POWER PLANT - NACELLE - POWERPLANT - DECAL, FAN COWL ENGINE OIL SERVICING ACCESS DOOR -
REPLACEMENT OF - CATEGORY CODE 5 - MOD.NAC-71-0136

V2500-NAC-71-0136

Replacement of Engine Oil Servicing Decal
Fig.1

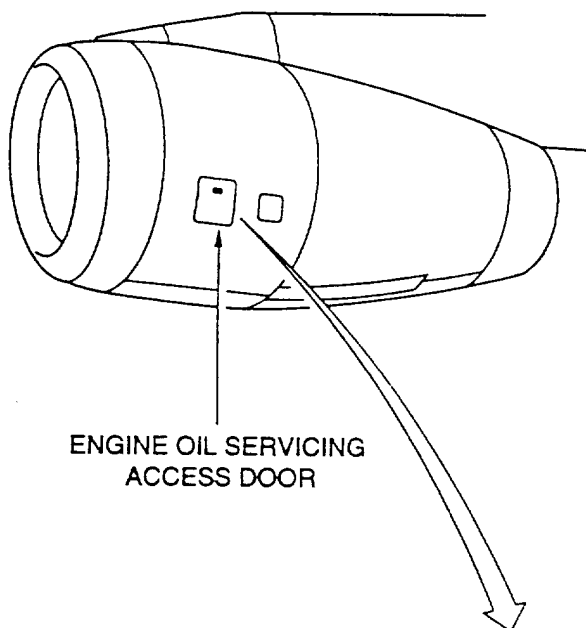
The decal on the oil servicing access panel quotes an oil quantity of 27.5 US quarts. This should read 29 US quarts.

- (a) The oil servicing access decal is removed and replaced with a new decal reflecting correct oil capacity quantity.

← REMOVE DECAL
740-3199-007

← INSTALL DECAL
740-3199-027

- (1) Find the decal on the outer surface of the engine oil servicing access door on the left fan cowl door. Refer to Figure 1.
- (2) Carefully remove the 740-3199-007 decal from the engine oil servicing access door on the left fan cowl door.
- (3) Remove any unwanted adhesive from the engine oil servicing access door.

(4) Remove the 740-3199-027 decal from its protective backing and put decal on the outer surface of engine oil servicing access door in the approximate center of the access door. Use firm hand pressure to make sure there are no ripples in the decal or air bubbles below the decal.
